Official Transcript of Proceedings
NUCLEAR REGULATORY COMMISSION

Title: Advisory Committee on Reactor Safeguards
 ABWR Subcommittee Meeting

Date: Thursday, May 20, 2010

Chapter 14

ABWR DCD Figure 7A-1 SSLC

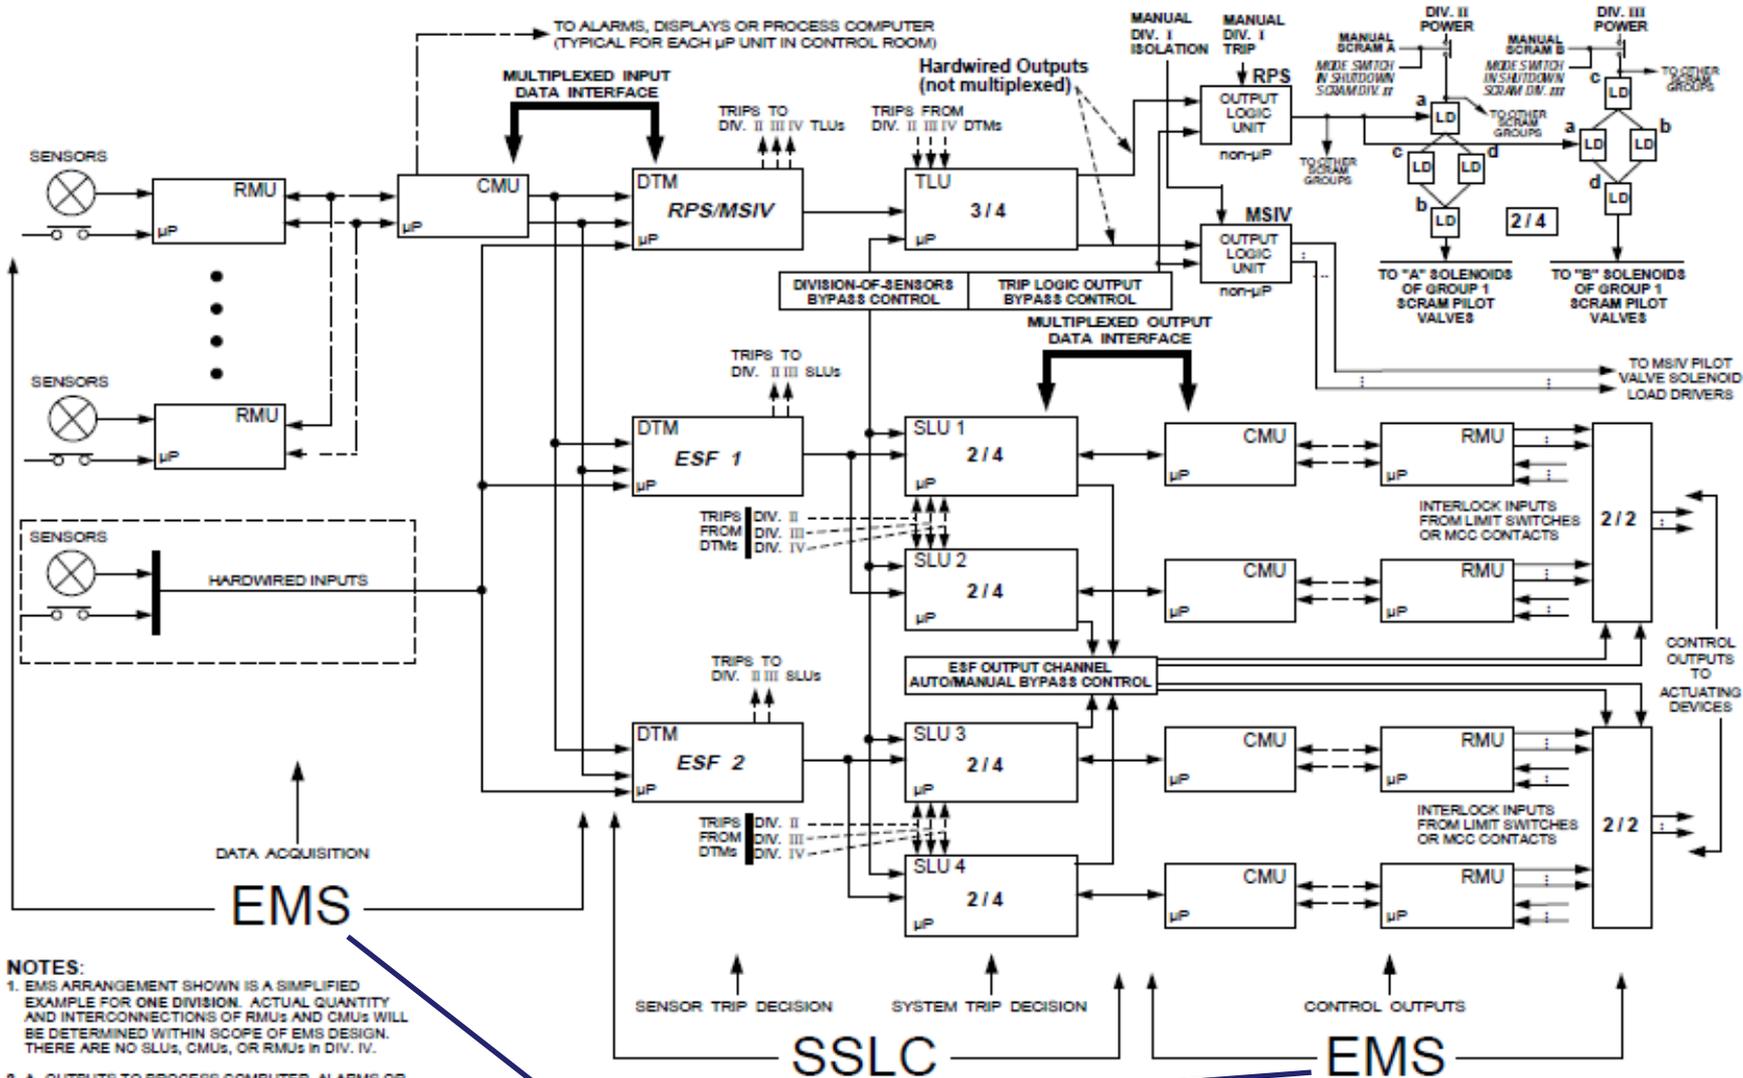
- Brief description (continued)
 - This departure does not change any of the SSLC functional requirements:
 - Tier 1, Section 2.2.5, “Neutron Monitoring System” – No Impact
 - Tier 1, Section 2.2.7, “Reactor Protection System” – No Impact
 - Tier 1, Section 2.4, “Core Cooling Systems” – No Impact

Fig. 7.9S-1 Data Communication Interfaces

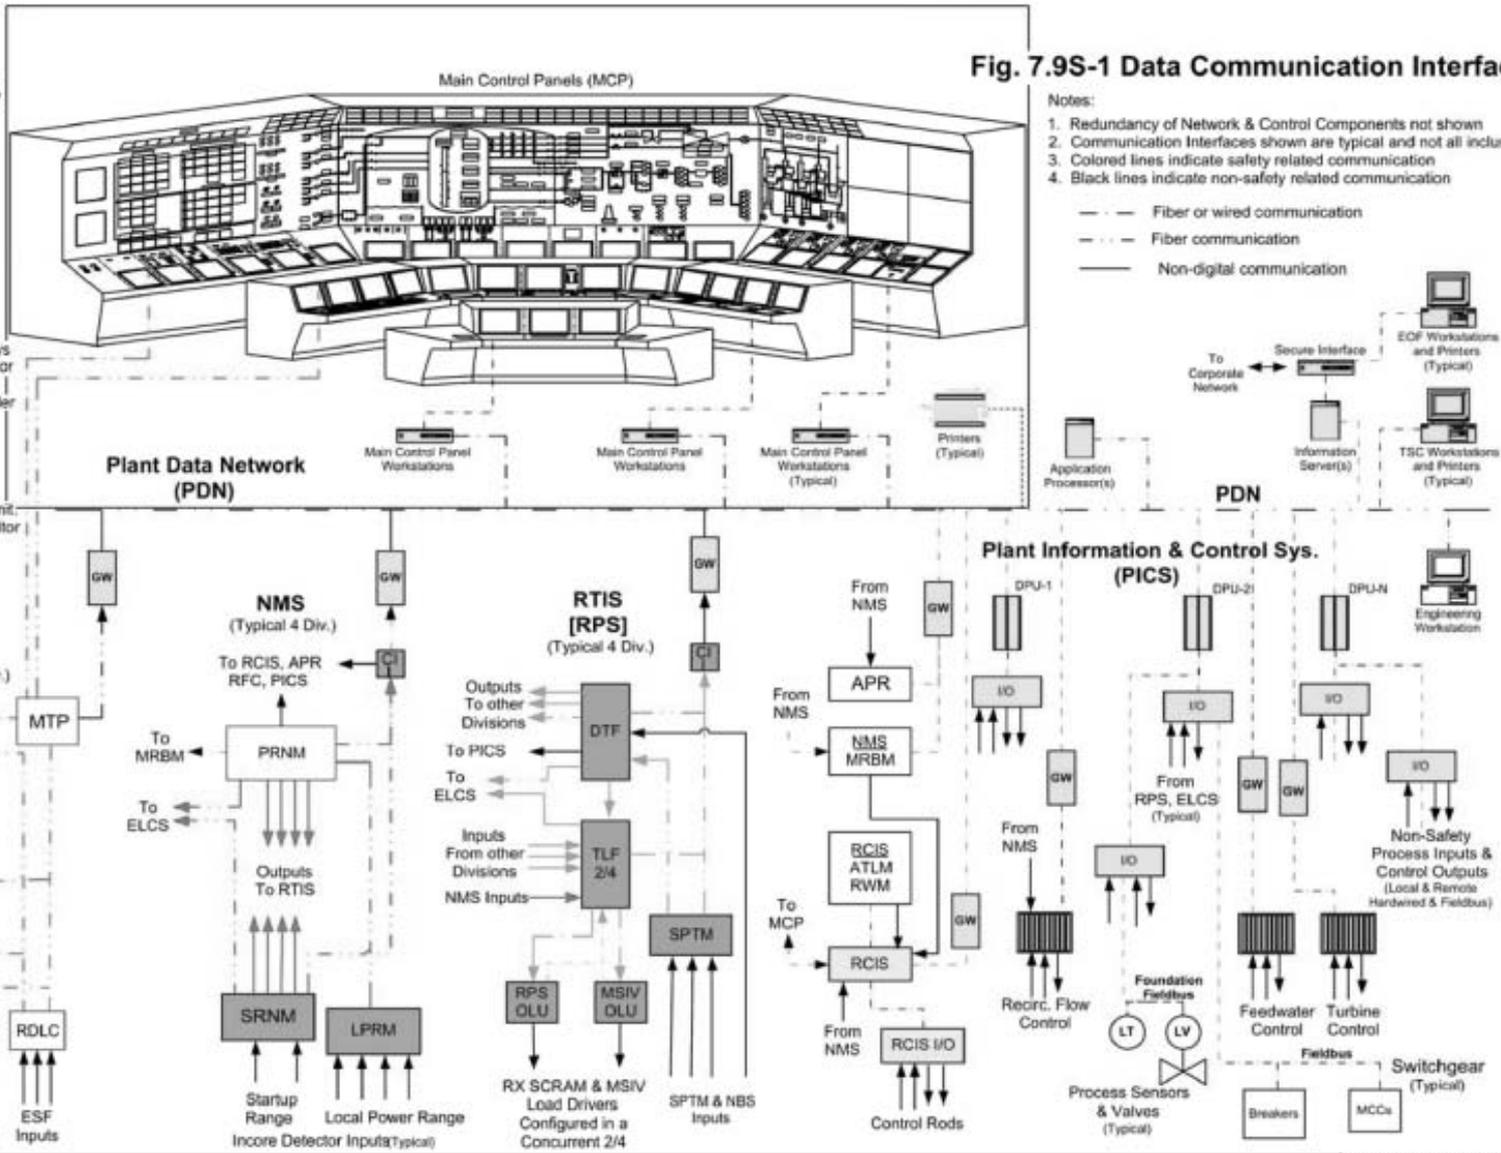
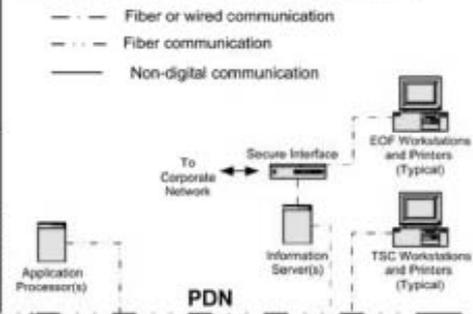
11 MR. DITTMAN: This Figure 7.9S-1 is in
12 the COLA, and what that is, you can basically take --

COLA Figure 7C-1 Implementation of Additional Diversity in SSLC to Mitigate Effects of CMF

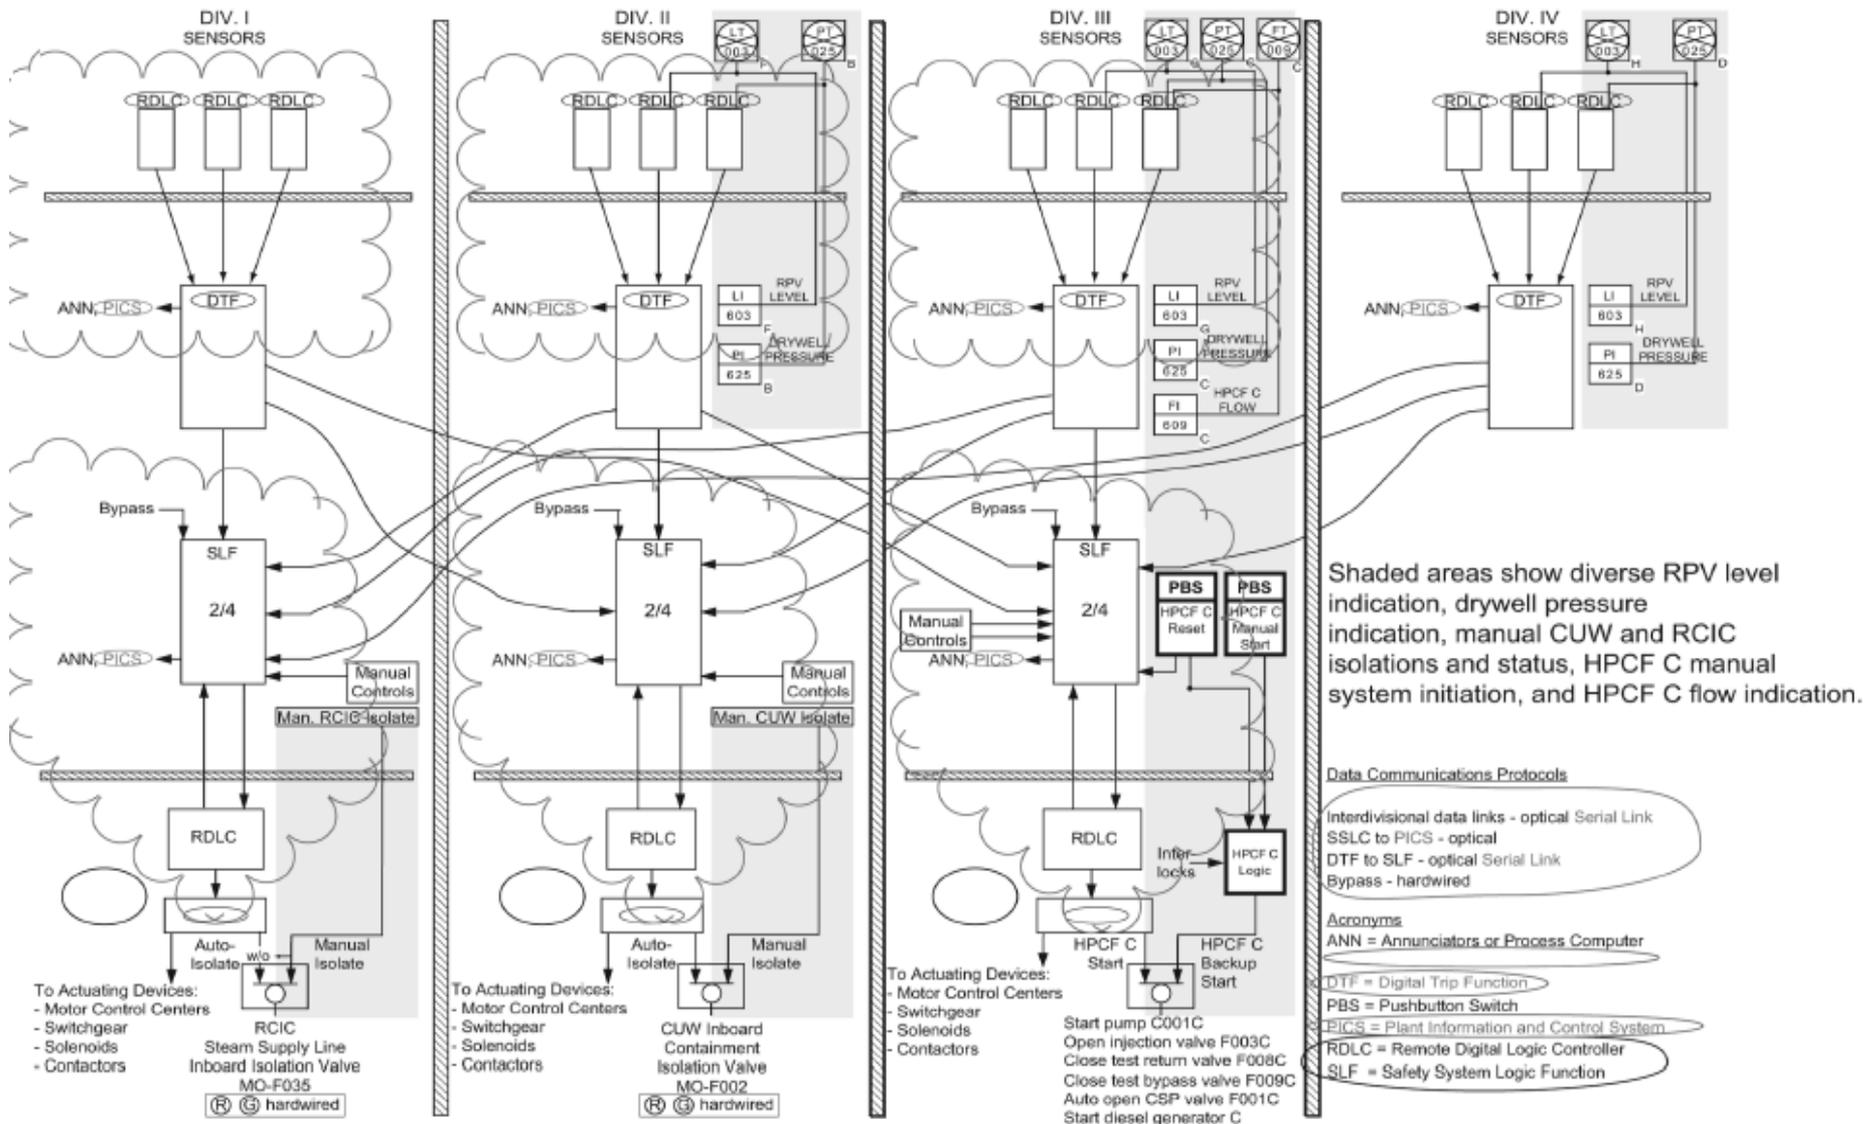
- Brief description
 - The certified U.S. ABWR design provides for diverse backup hardwired capabilities for reactivity control (reactor trip), core cooling (ESF actuation), containment isolation, and supporting diverse displays to cope with a postulated worst-case event, i.e., undetected 4-division common mode failure of all communications or logic processing functions in conjunction with a large break LOCA.
 - STP 3 & 4 COLA incorporates by reference (**IBR**) the diversity and defense-in-depth consideration and resulting diverse backup design features of the certified ABWR design **with no departures**.

- Specific items of interest (continued)
 - In STP 3 & 4 I&C design, the hard wired diverse features are independent of all digital I&C systems as illustrated in STP 3 & 4 FSAR Figure 7C-1.
- Conclusion
 - Although STP 3 & 4 I&C design has reduced concerns with CMF in digital I&C systems, it incorporates diverse backup design features of the certified ABWR design with no departures.
